UNITED STATES PATENT AND TRADEMARK OFFICE

APPLICATION NO.	FILING DATE	FIRST NAMED INVENTOR	ATTORNEY DOCKET NO.	CONFIRMATION NO.
10/680,166	10/08/2003	Yasushi Yamagoshi	040894-5958	5804
9629	7590	03/13/2006	EXAMINER	
MORGAN LEWIS & BOCKIUS LLP 1111 PENNSYLVANIA AVENUE NW WASHINGTON, DC 20004			WATKO, JULIE ANNE	
		ART UNIT	PAPER NUMBER	2653

Office Action Summary	Application No.	Applicant(s)	
	10/680,166	YAMAGOSHI, YASUSHI	
	Examiner	Art Unit	
	Julie Anne Watko	2653

Morioka Fig. 2, annotated

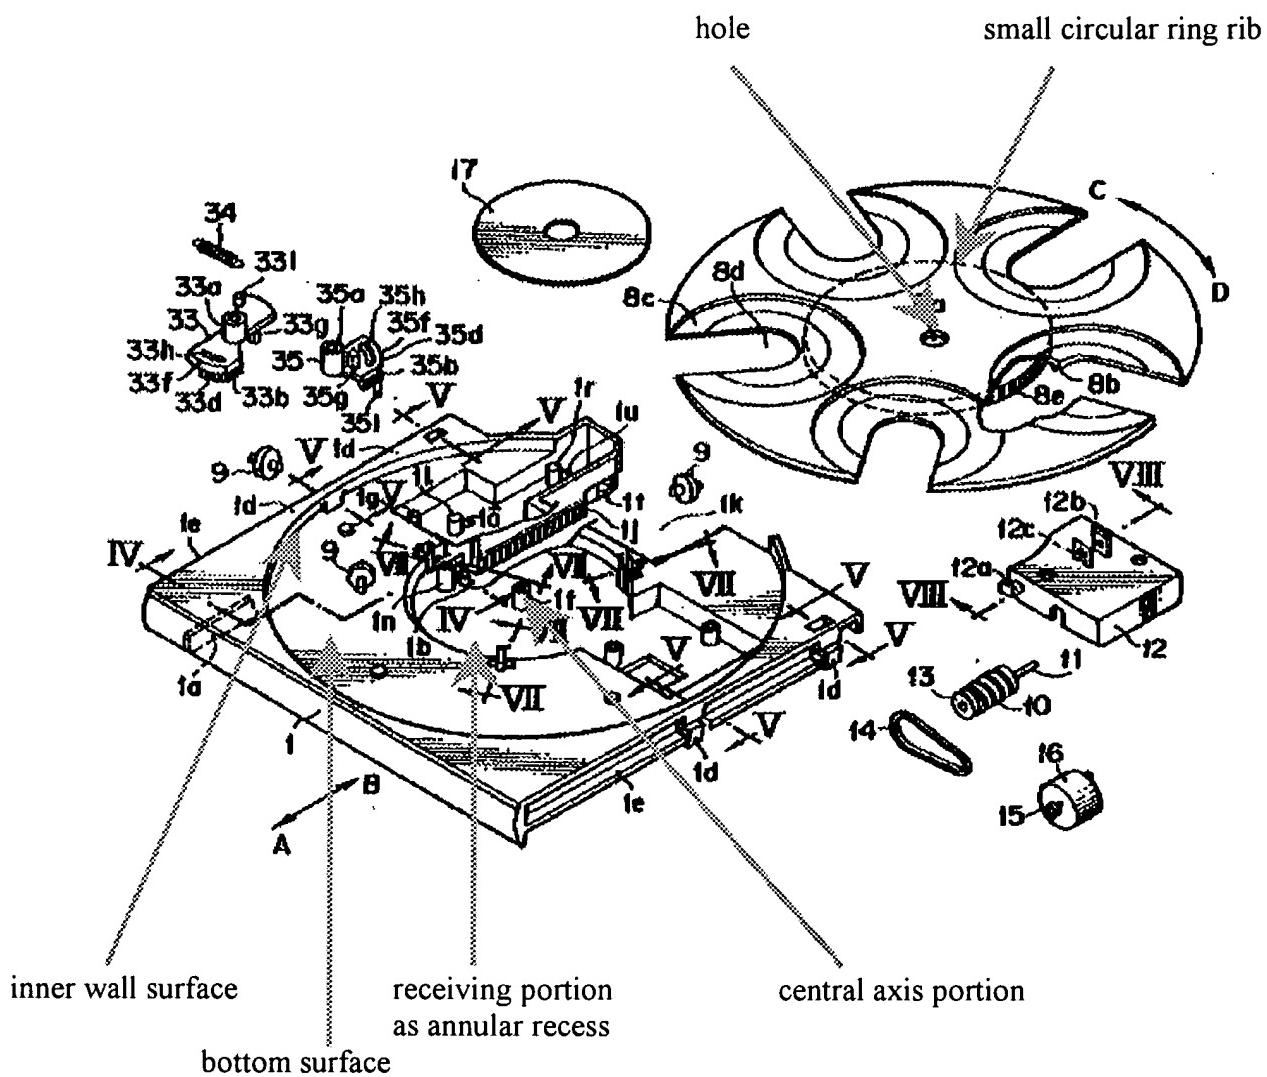
As recited in claim 2, to the extent understood, Morioka shows a disk table rotation structure, comprising: a tray 1 having an inner supporting wall surface (see Fig. 2, annotated below) that stands upward, inside of the inner wall surface, a central axis portion 1F that stands upward on a center portion of the bottom surface, and a receiving portion disposed around the central axis portion; a disk table 8 having a central through hole portion 8a opened in a center portion and into which the central axis portion is inserted, and a small circular-ring rib 8e extending downward from a periphery of the central through hole portion, the small circular-ring

rib positioned close to the bottom surface of the tray to support rotatably the disk table on the tray.

As recited in claim 3, Morioka shows that the receiving portion is an annular recess formed on the bottom surface of the tray (see Fig. 2, annotated above).
